PROJECT TITLE
Constitutional and Marksheffel

DATE: January 3 2019

A200

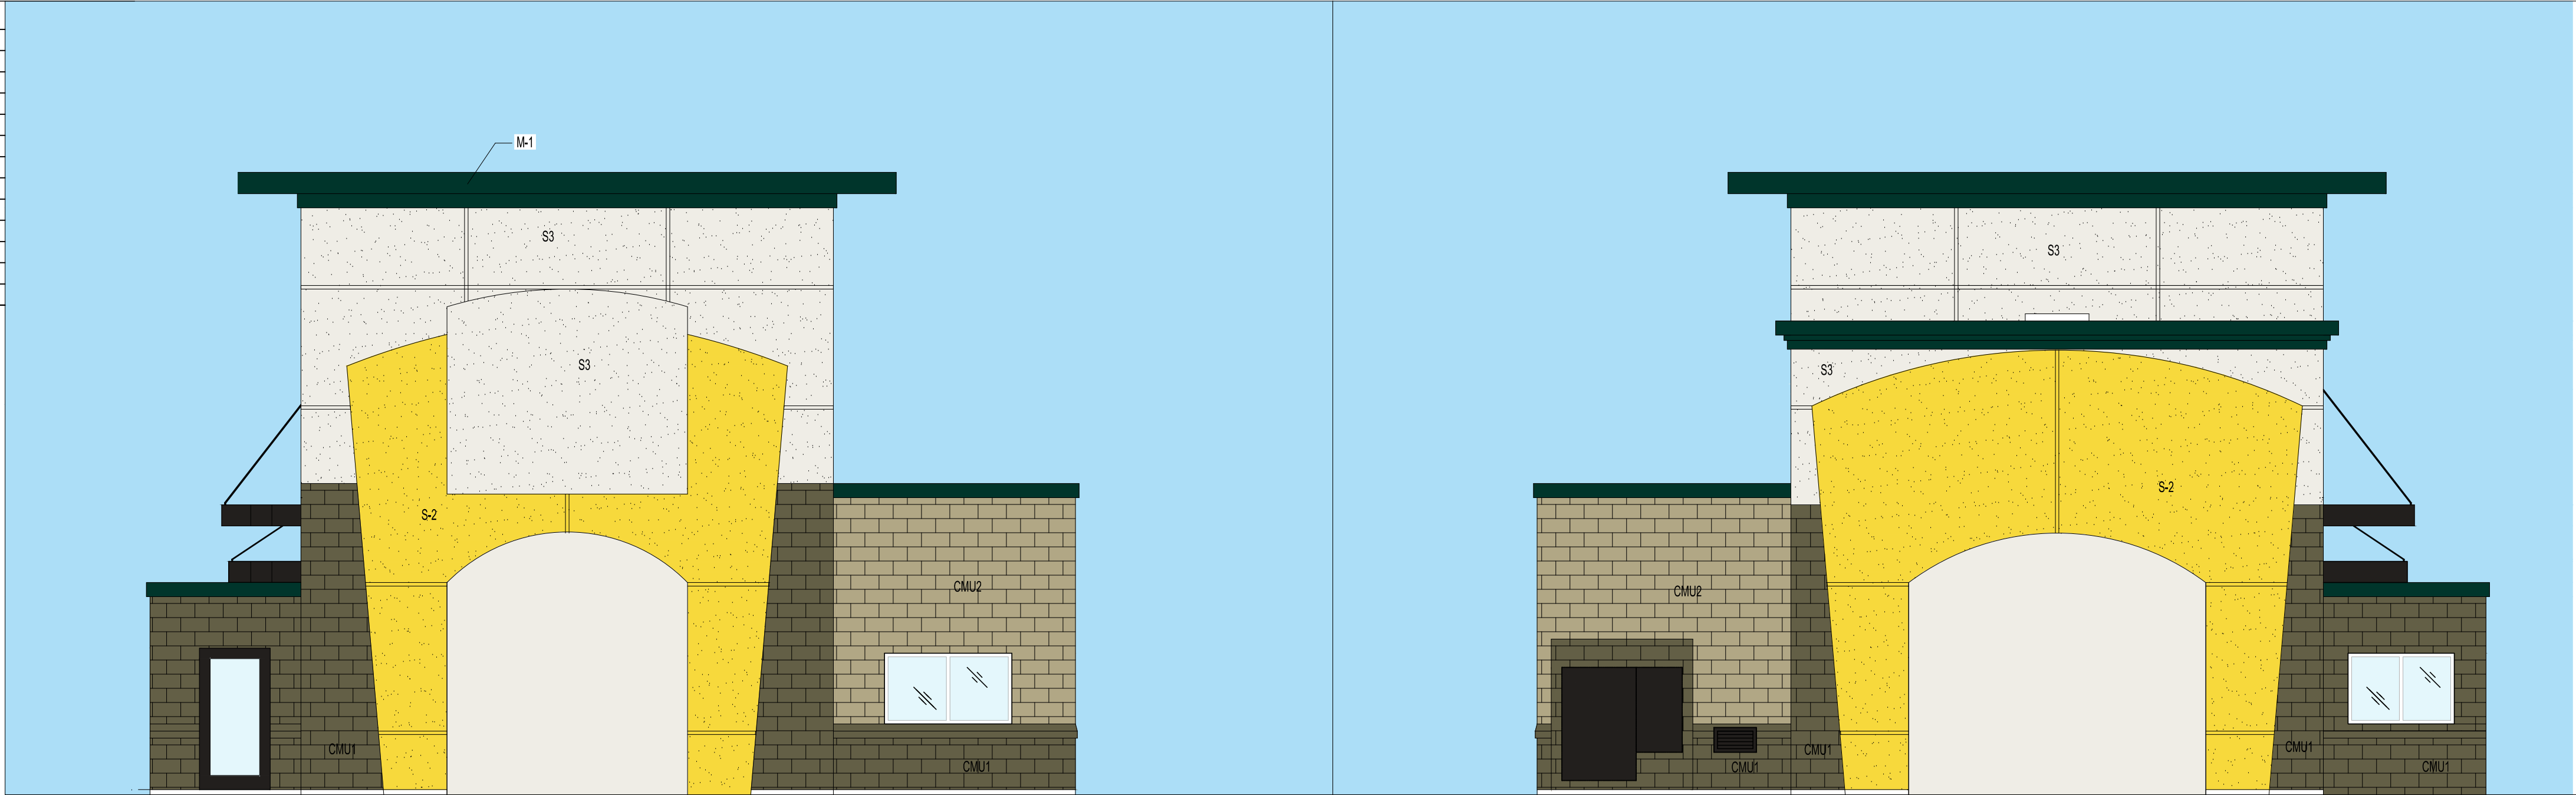
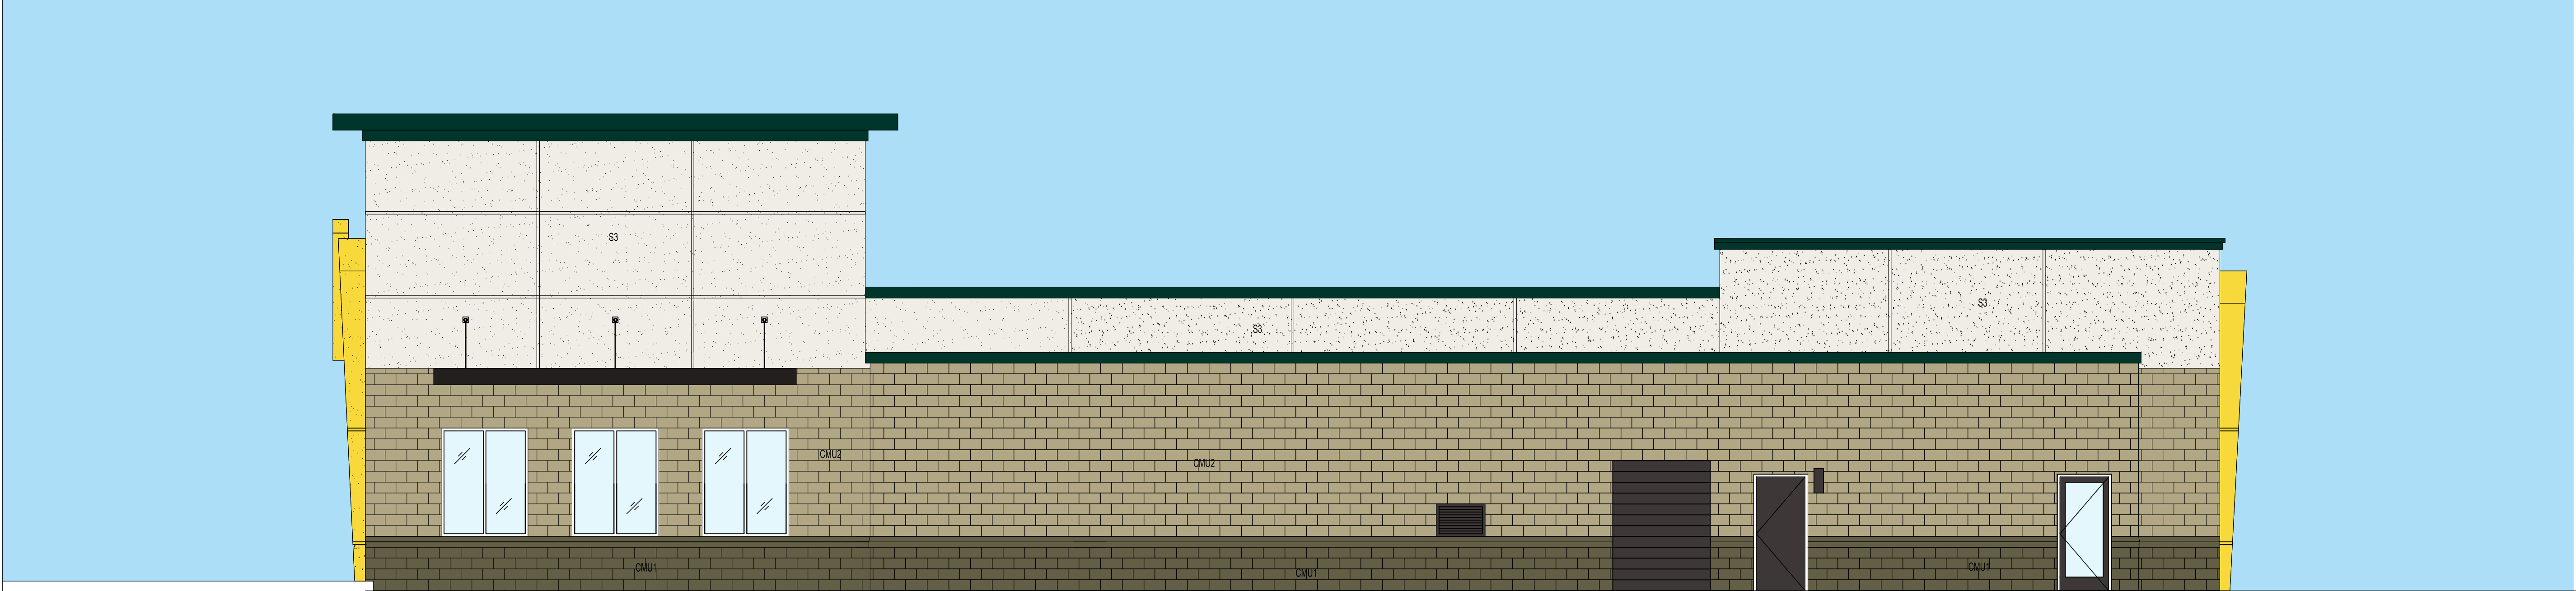
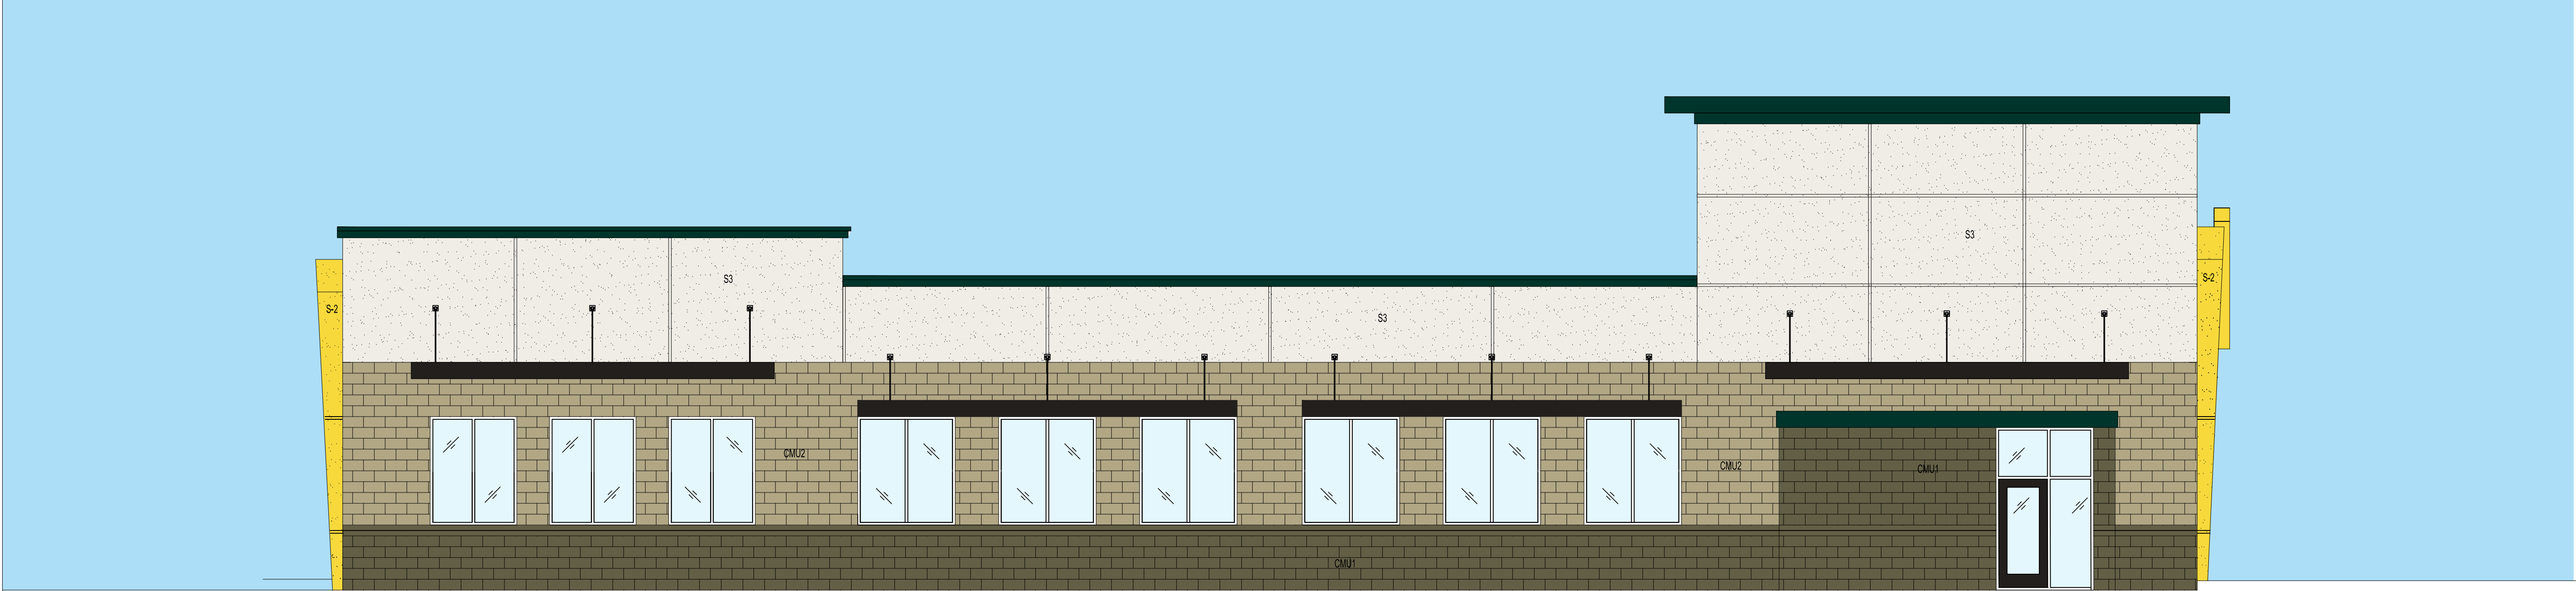
Elevations of the structure are required on the plan to verify the height restrictions are met

Please include elevations of the vacuum canopy

EXTERIOR ELEVATION

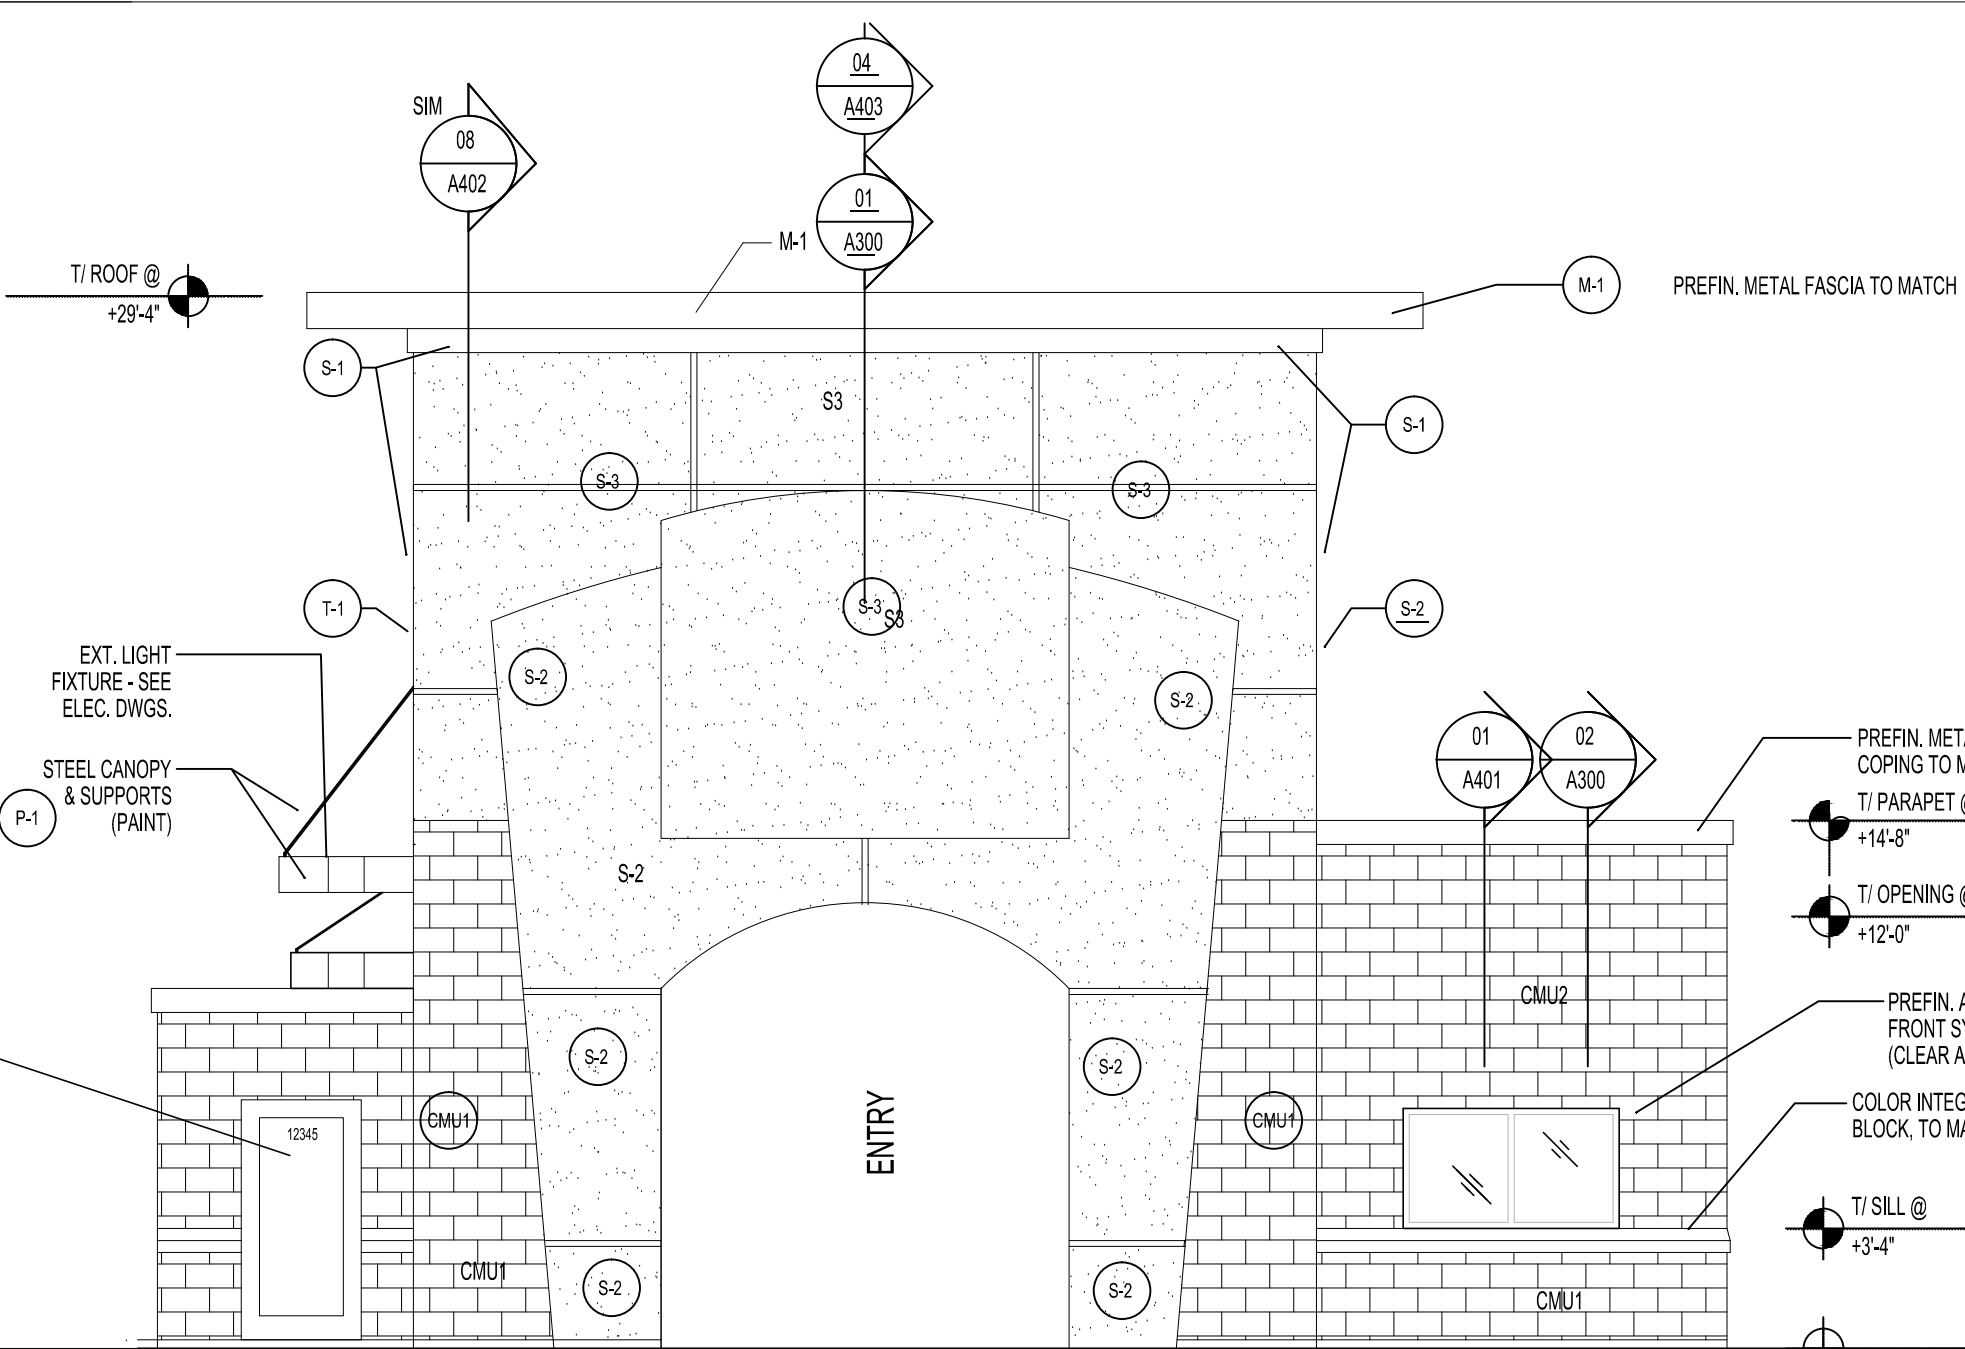
Provide approved address identification. The address identification shall be legible and placed in a position that is visible from the street or road fronting the property. Address identification characters shall contrast with their background. Address numbers shall be Arabic numbers or alphabetical letters. Numbers shall not be spelled out. Each character shall be a minimum of 4 inches (102 mm) high with a minimum stroke width of 1/2 inch (12.7 mm)
Verify Approved Address With Eagle Mountain
